PIVOT ARCHITECTURE

ADDENDUM # 5

Project: **Klamath Community College Childcare Learning Center (2331.00)**

Date: September 4, 2025

SEE STRUCTURAL FOR TREE PLANS, SECTIONS AND DETAILS

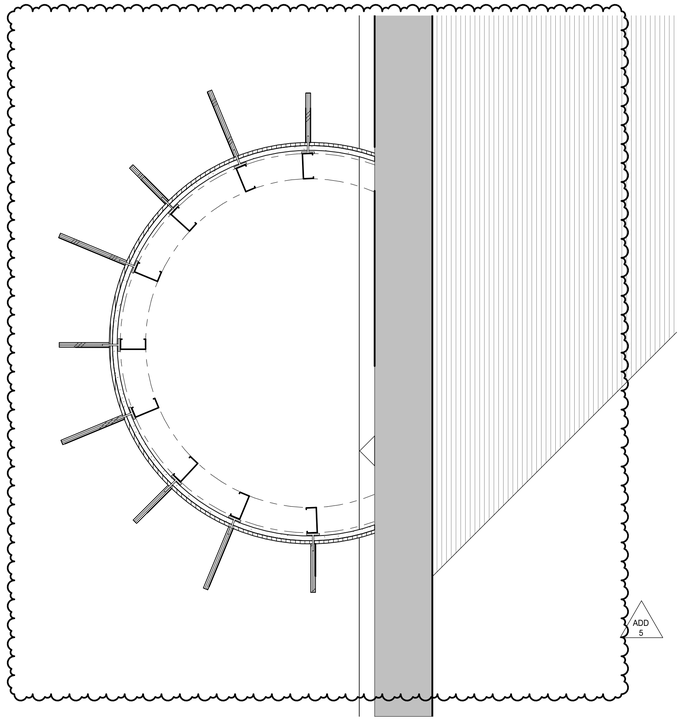
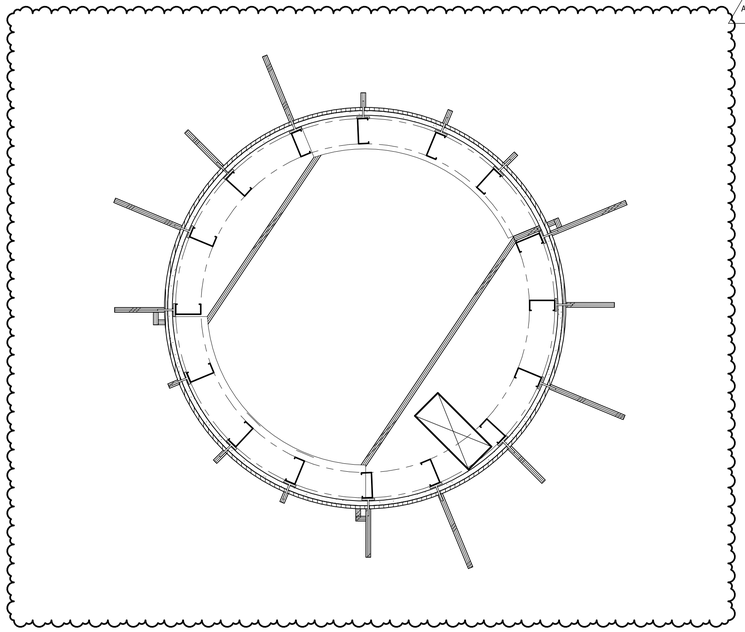
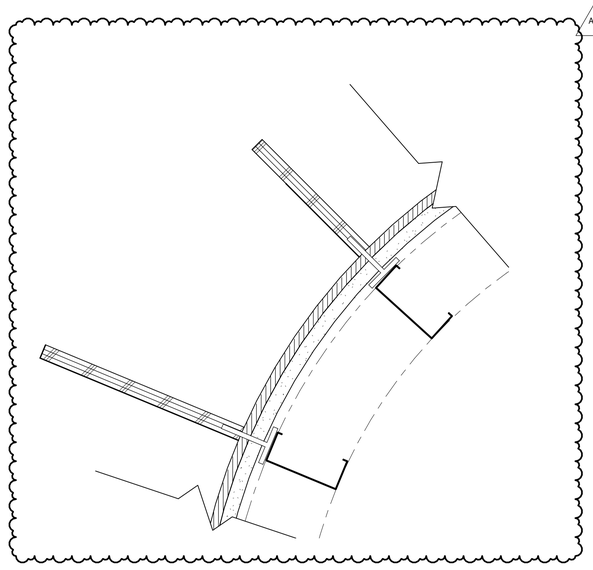
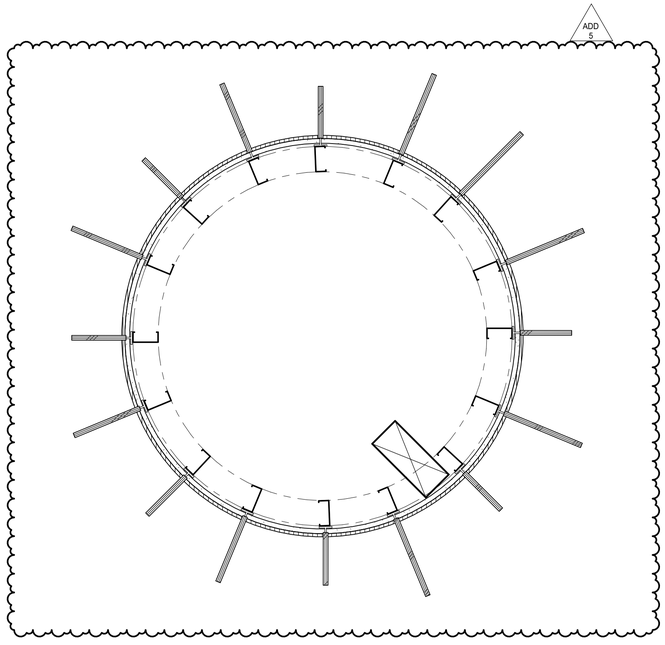
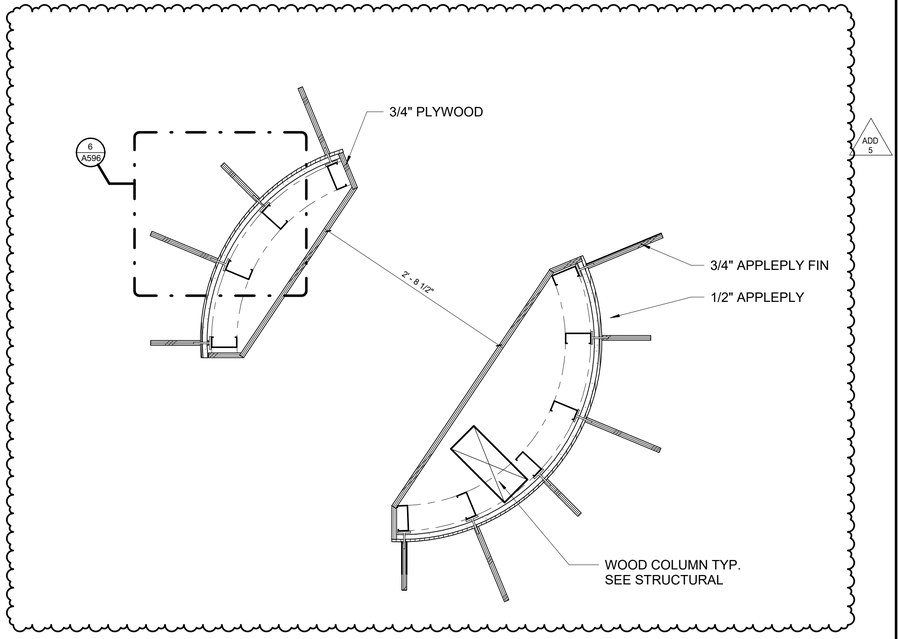
3.40. A596 ENLARGED PLAN & DETAILS – TREE
3.40.1. REMOVED wood construction from tree plans.
3.40.2. ADDED metal studs.
3.40.3. REMOVED ANNOTATIONS – Waiting for structural drawings to annotate drawings further.
3.40.4. ADDED Note - “SEE STRUCTURAL FOR TREE PLANS, SECTIONS, AND DETAILS

A633

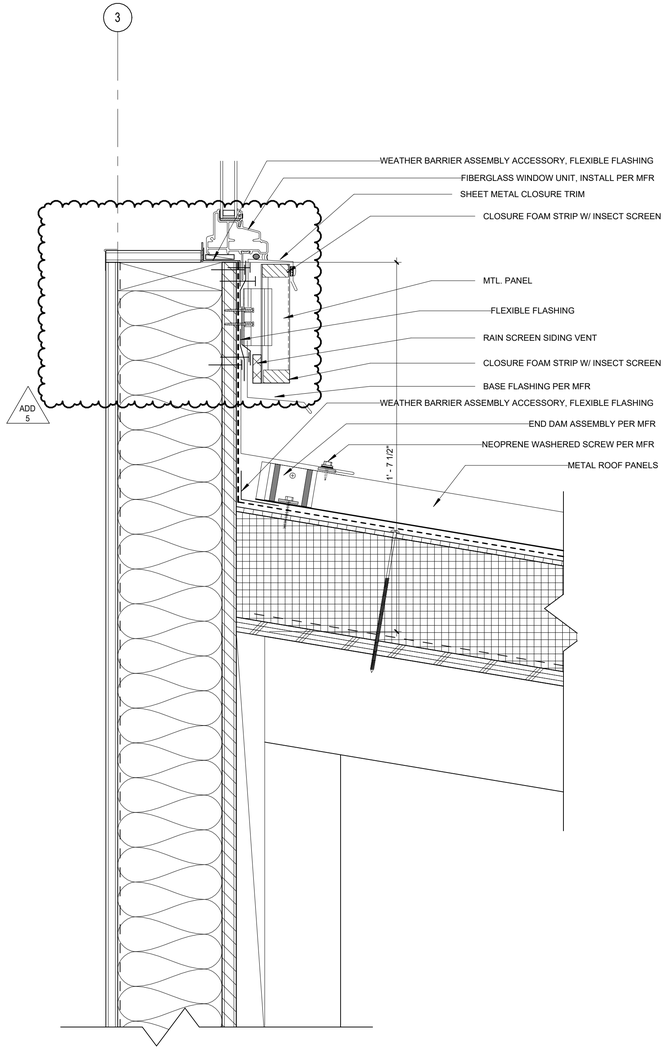
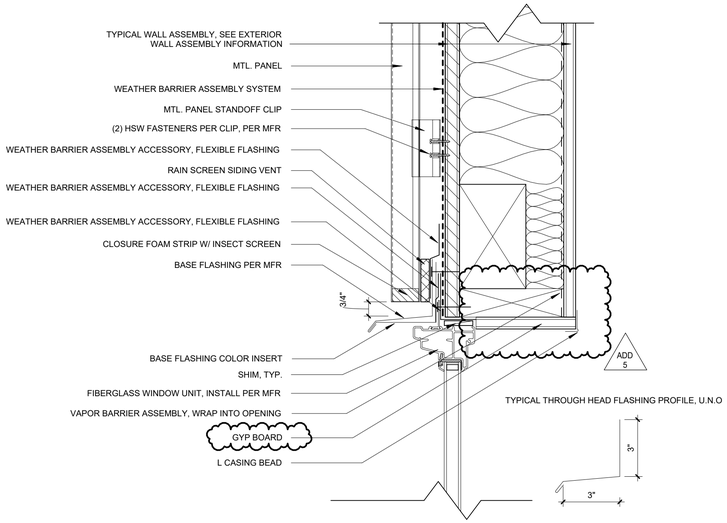
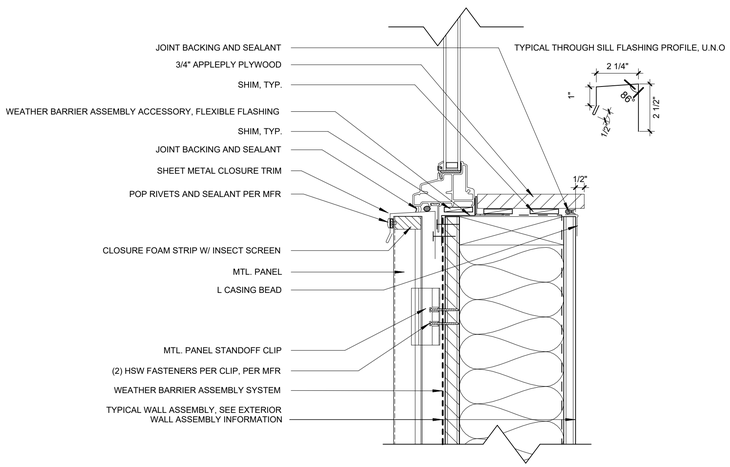
3.43. A633 WINDOW DETAILS
3.43.1. REVISED, details to show gyp surround
3.43.2. REVISED, alpolic panel changed to metal panel per elevation

4 STOREFRONT HEAD @ HSS SPANDREL
3" = 1'-0"

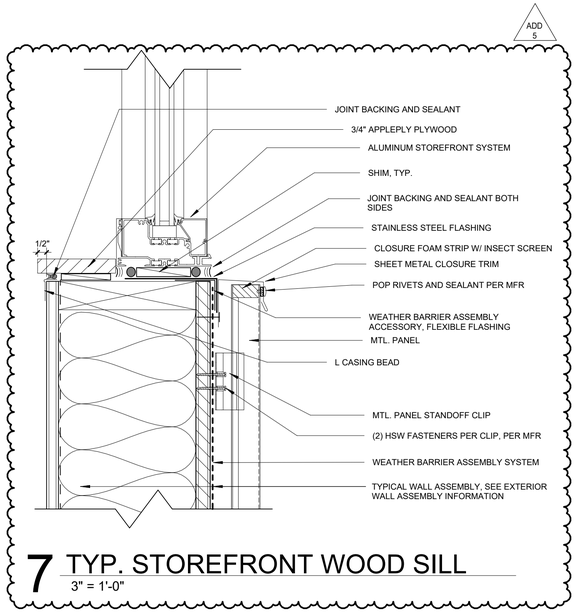
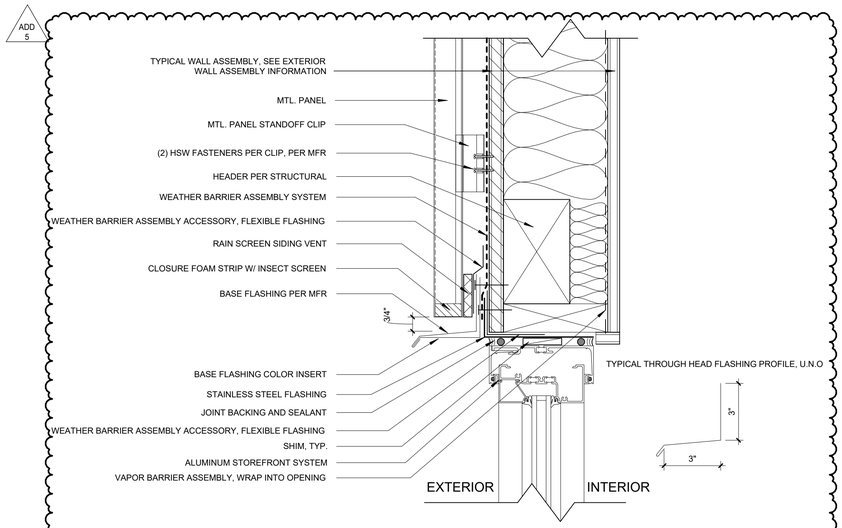
3.44. A637 STOREFRONT DETAILS
3.44.1. REVISED, details to show gyp surround
3.44.2. REVISED, HSS spandrel to proper size
3.44.3. ADDED, sill details for gyp and wood

1 S111 FOUNDATION PLAN - SECTOR A
1/8" = 1'-0"

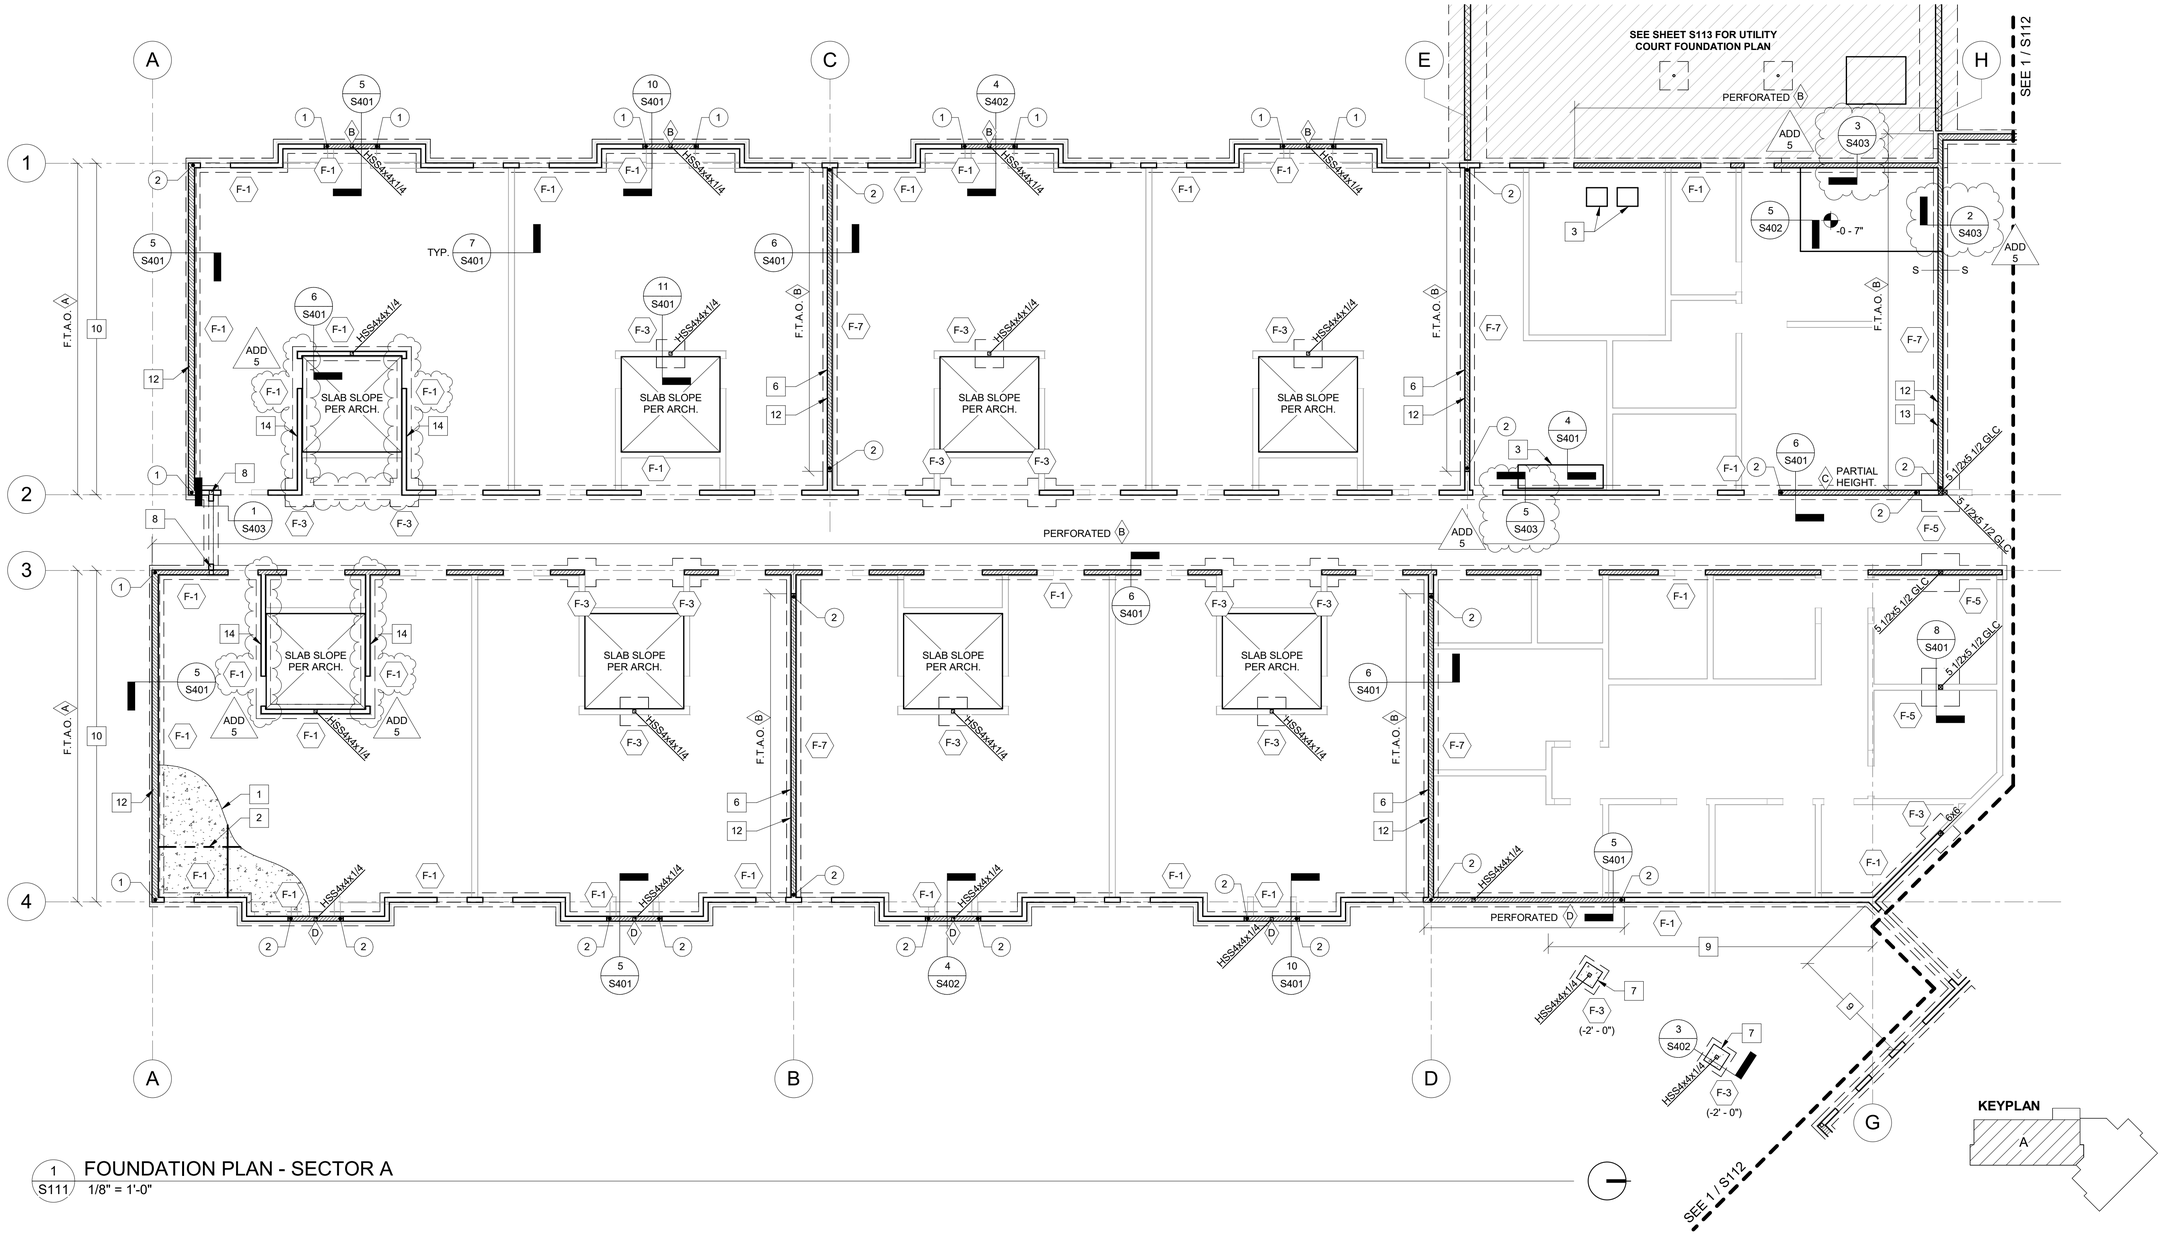
3.46. S111 FOUNDATION PLAN – SECTOR A

3.46.1. Added detail callout for housekeeping pad at stud wall.

3.46.2. Added strip footings under walls at mechanical mezzanines

S112

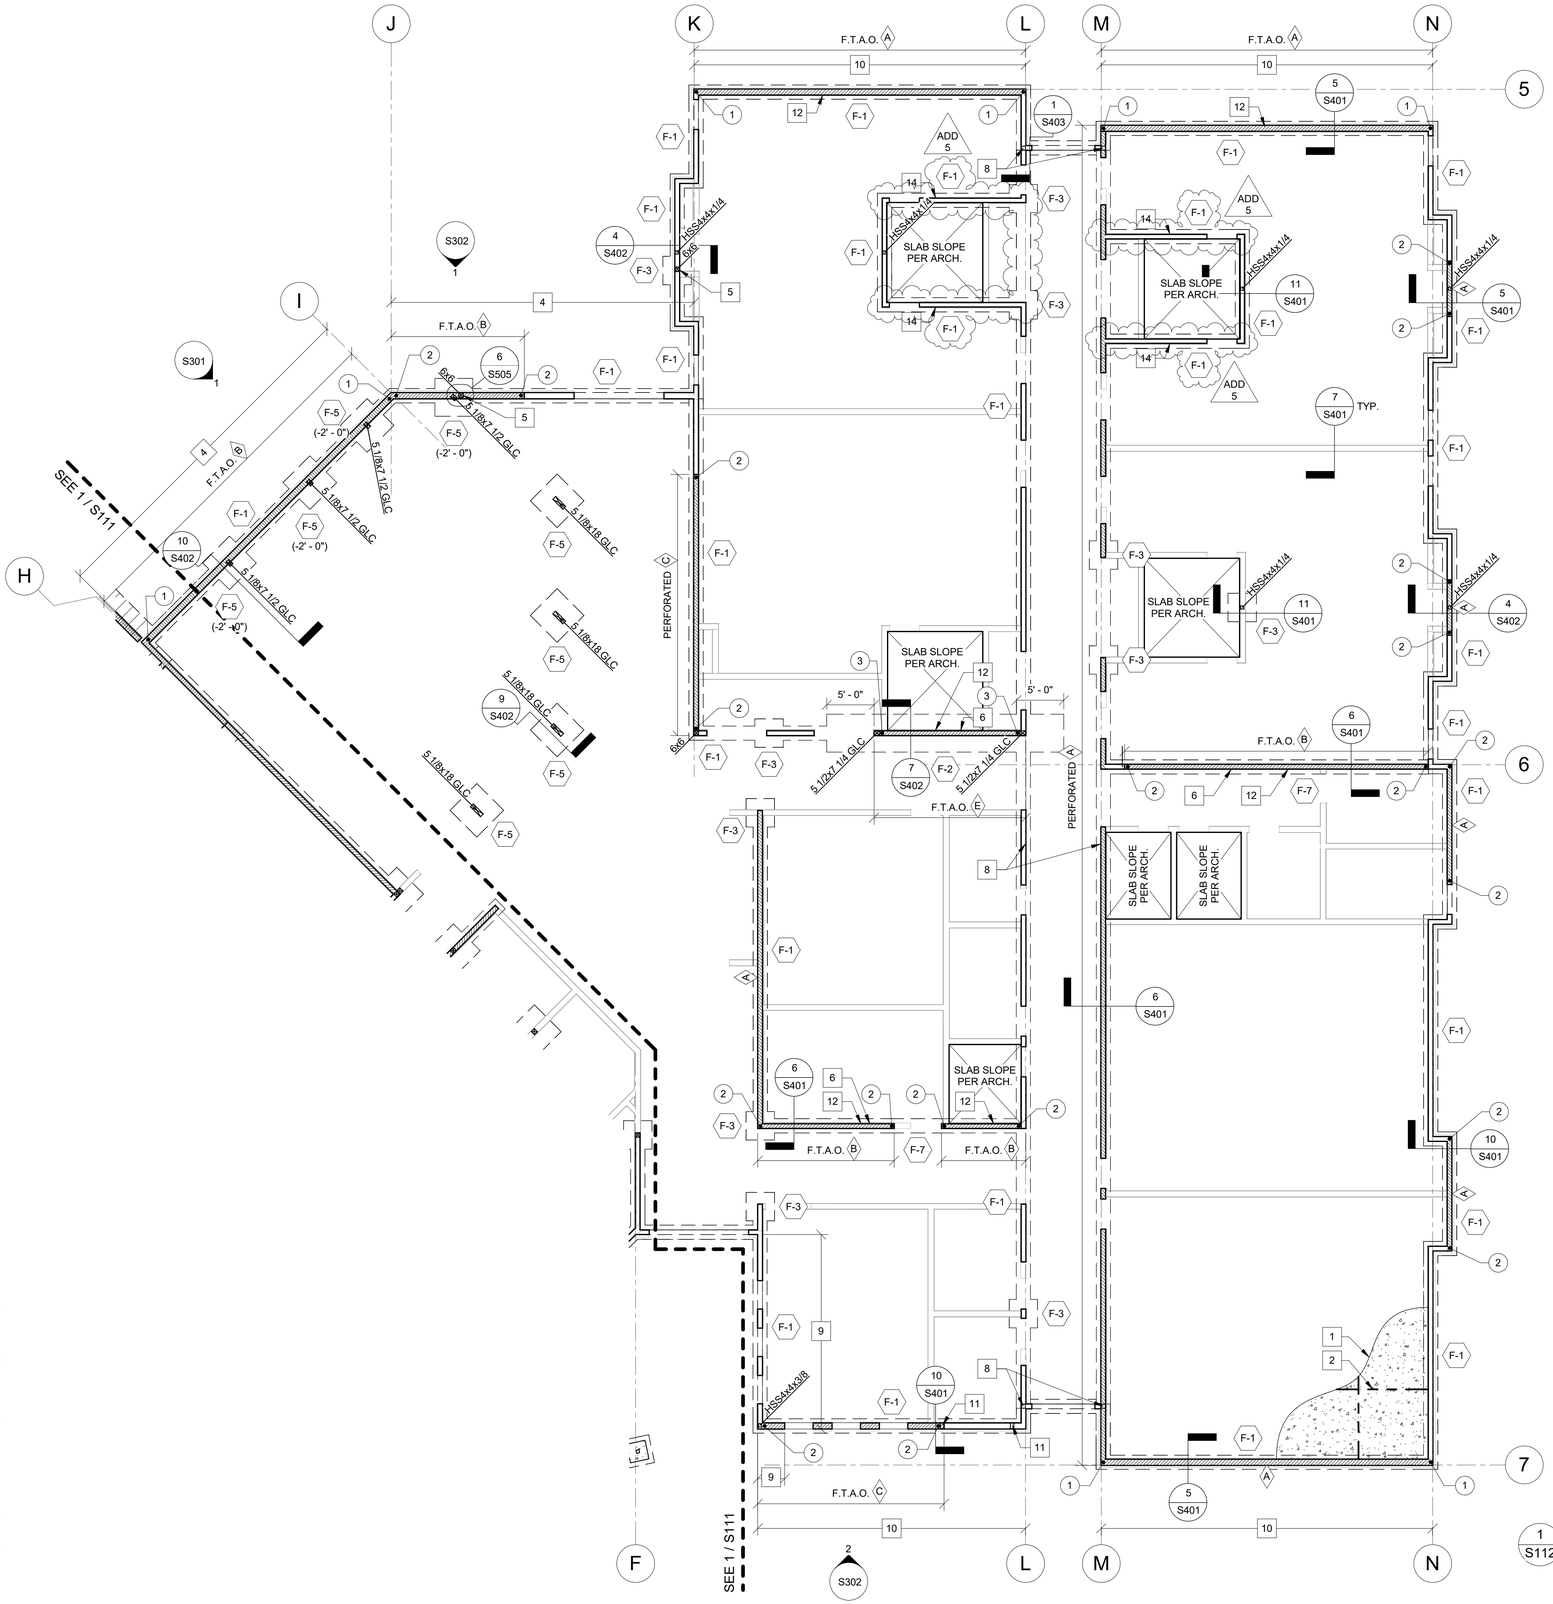
3.47. S112 FOUNDATION PLAN – SECTOR B

3.47.1. Added strip footings under walls at mechanical mezzanines
